April 10, 2019

We are responding to a request for public comment on the Initial Study/Mitigated Negative Declaration For Sewer Interceptor Improvements Project. Please note there is one attachment and please acknowledge receipt of these documents.

Figure 1 High Level Map of PacifiCorp's California Transmission Assets by Geographic Fire Tier

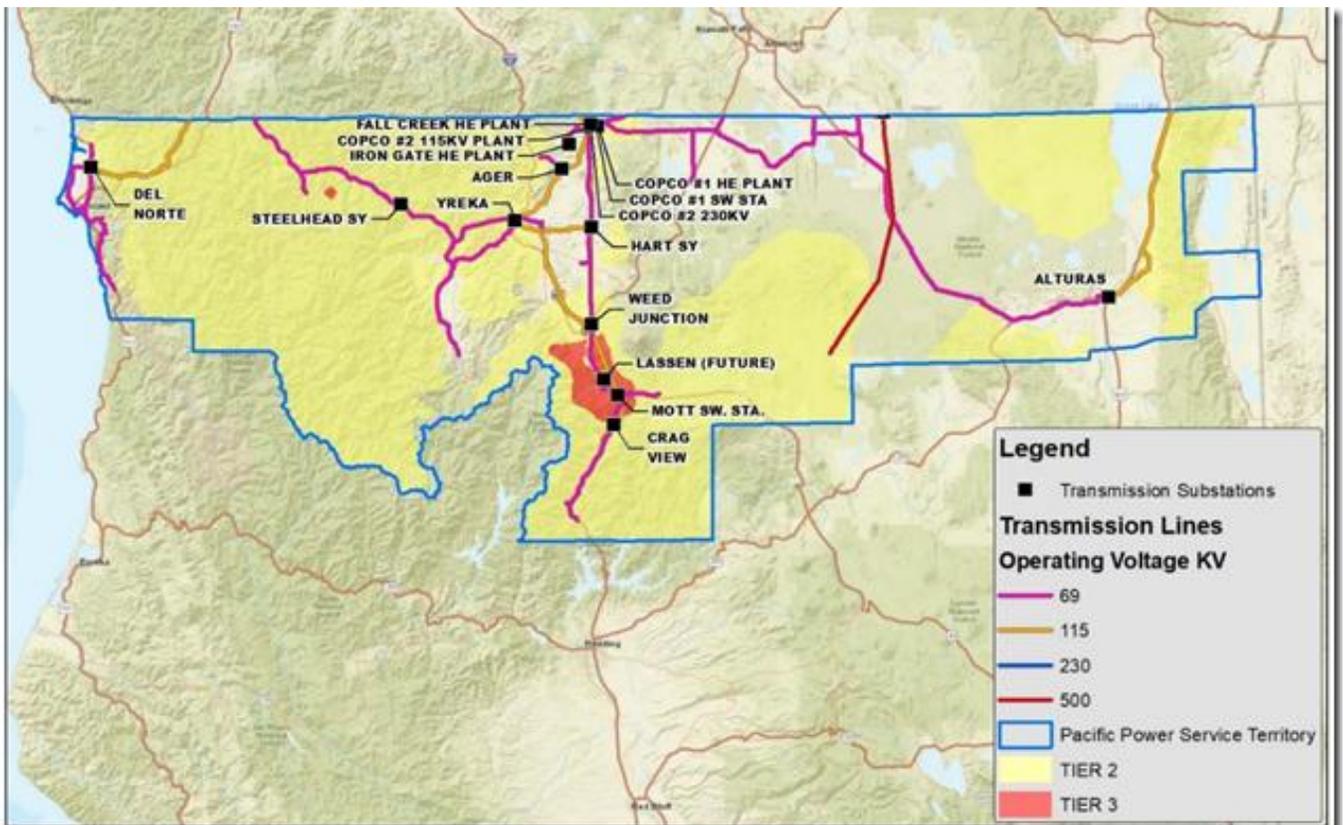
4) While the IS/MND mentions the Lassen substation and transmission line upgrades in the context of other construction projects in the vicinity, it fails to acknowledge and explore the opportunity to underground the transmission lines to increase the community's resilience to wild fire in conjunction with the interceptor line. Underground transmission lines could be installed in a coordinated project with the interceptor line (to save money), possibly even in the same trench that the interceptor line will be in, or in parallel trenches in the same area, dug at the same time. We find it extremely alarming that Pacific Power refuses to put the upgraded transmission lines underground, in spite of the fact that the area of these upgrades and the City are in Tier 3 ("extreme") wild fire hazard areas as designated by the CPUC itself. The CPUC defines Tier-3 as follows:

**"Tier 3 fire-threat areas depict areas where there is an extreme risk (including likelihood and potential impacts on people and property) *from utility associated wildfires.*"** (italic emphasis added). Mount Shasta City and the Lassen substation sit squarely in the middle of a Tier-3 area (see CPUC map below). Much of the rest of the County is designated "only" Tier-2 ("elevated" risk). **The CPUC has not yet approved Pacific Power's project.** There may still be time for the City to intervene and demand undergrounding of the transmission lines.
